Draft Sydney development control plan 2012 amendment – Parramatta Road precinct

Draft Sydney Development Control Plan 2012 – Parramatta Road Precinct

Development Control Plan
November 2026

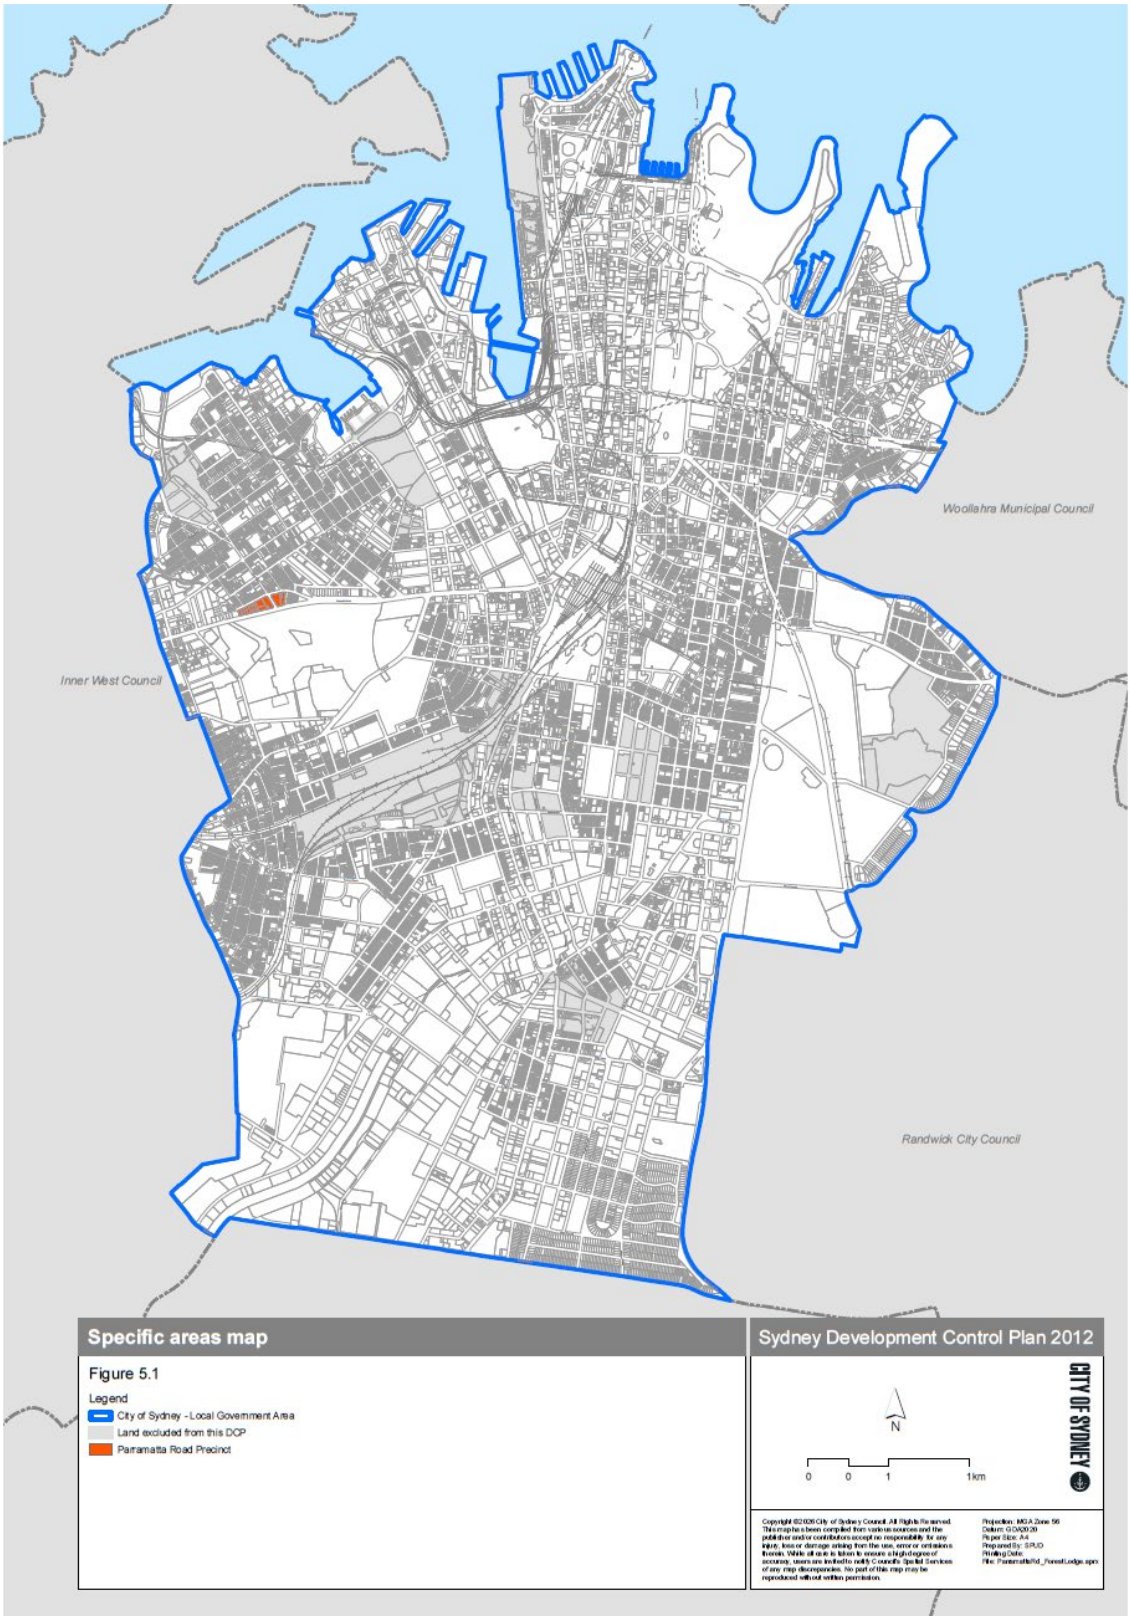
1. Replace Figure 5.1 Specific areas map in accordance with the new map at Appendix 1.
2. Insert a new sub-section at the end of Section 5 in accordance with Appendix 2.
3. Amend DCP map sheets 2 and 9 in accordance with Figures provided in Appendix 3.
4. Amend Section 2.6.1 in accordance with Appendix 4.

1. Update Figure 5.1 to show the Figure provided below:

Figure X: Building articulation zone

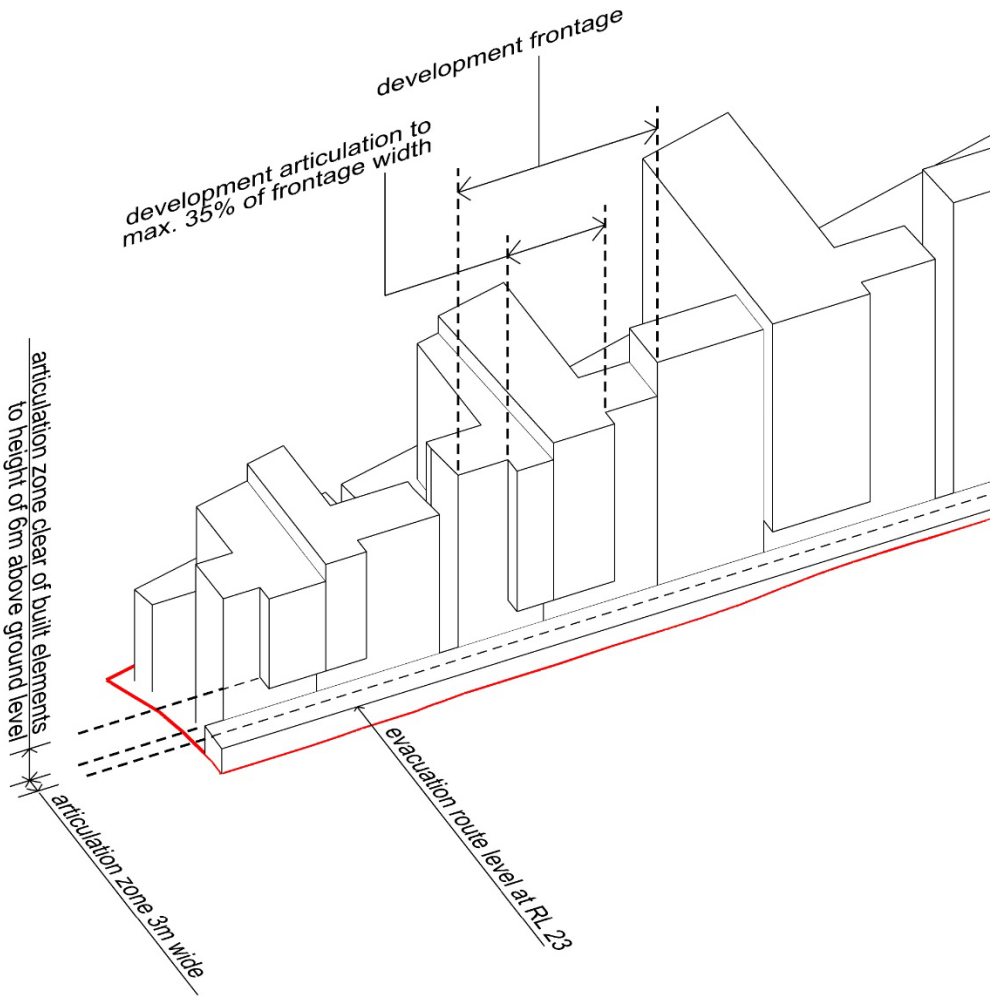
(1) Building articulation zones are to be provided in the locations shown in Figure X: Urban principles and as shown in Figure X: Building articulation zone.

(2) The building articulation zone must be:

a) clear of built elements for a height of 6m above the level of the pedestrian evacuation route; and

b) occupied up to a maximum 35% of its area at levels above ground level.

Figure X: Minimum residential finished floor levels of flood-affected land.

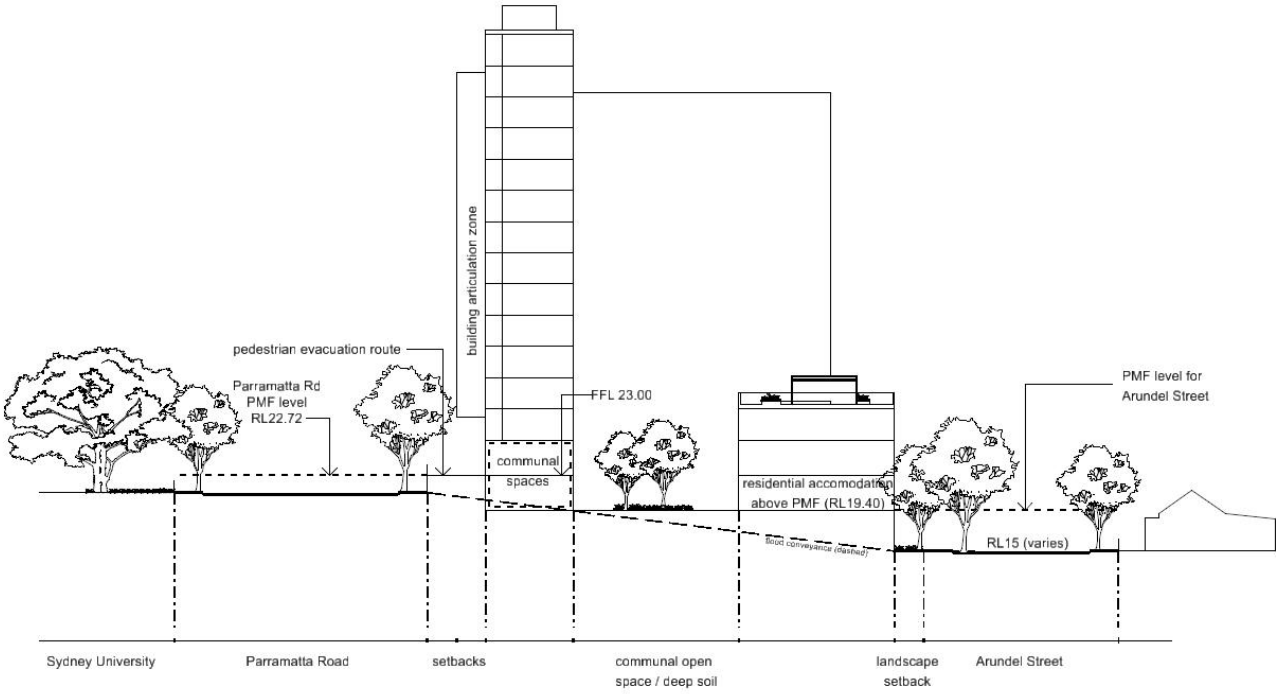
(3) Residential accommodation is to have a minimum finished floor level no lower than the probable maximum flood level as shown on Figure X: Minimum residential finished floor levels of flood-affected land.

(4) Non-residential floor space is to have a minimum finished floor level no lower than the 1% annual exceedance probability flood planning level.

Figure X: Pedestrian evacuation route - plan

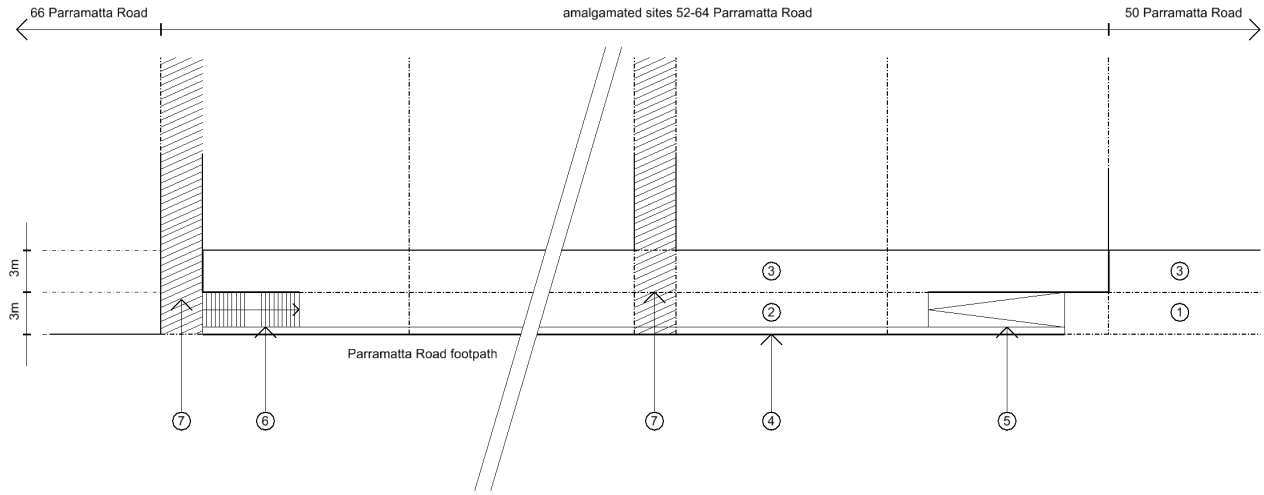
(6) The pedestrian evacuation route is to be constructed in accordance with Figure X: Pedestrian evacuation route plan and Figure X: Pedestrian evacuation route section

(7) Retaining walls, associated with the pedestrian evacuation route are to:
   a) be constructed of, or faced with, natural sandstone and complement the character of Chapman Steps; and
   b) incorporate steel balustrades in accordance with the Sydney Streets Technical Specifications and Standard Drawings.

(8) The pedestrian evacuation route, including stairs and ramps, must:
   a) be capable of being connected to neighbouring flood-affected land so that when all flood-affected land is developed the pedestrian evacuation route forms a continuous flood-free and accessible connection from all developments to the flood-safe access point;
   b) be accessible to all people; and
   c) the finished level of the evacuation route is RL23, descending to the flood-safe access point.

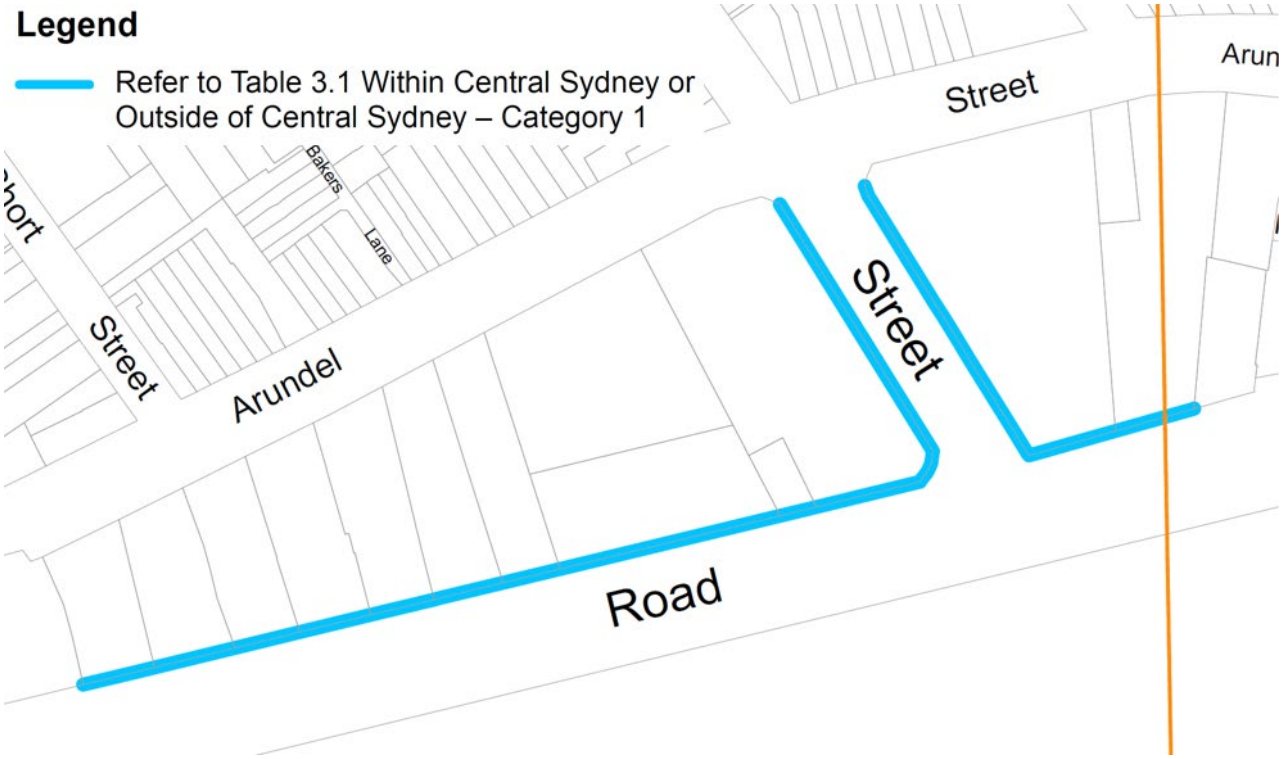
1. Amend DCP map sheets 2 and 9 as follows:

(a) Active frontages map:

(b) Building setback and alignment map:

(c) Footpath, awnings and colonnades map:

(d) Height in storeys map:
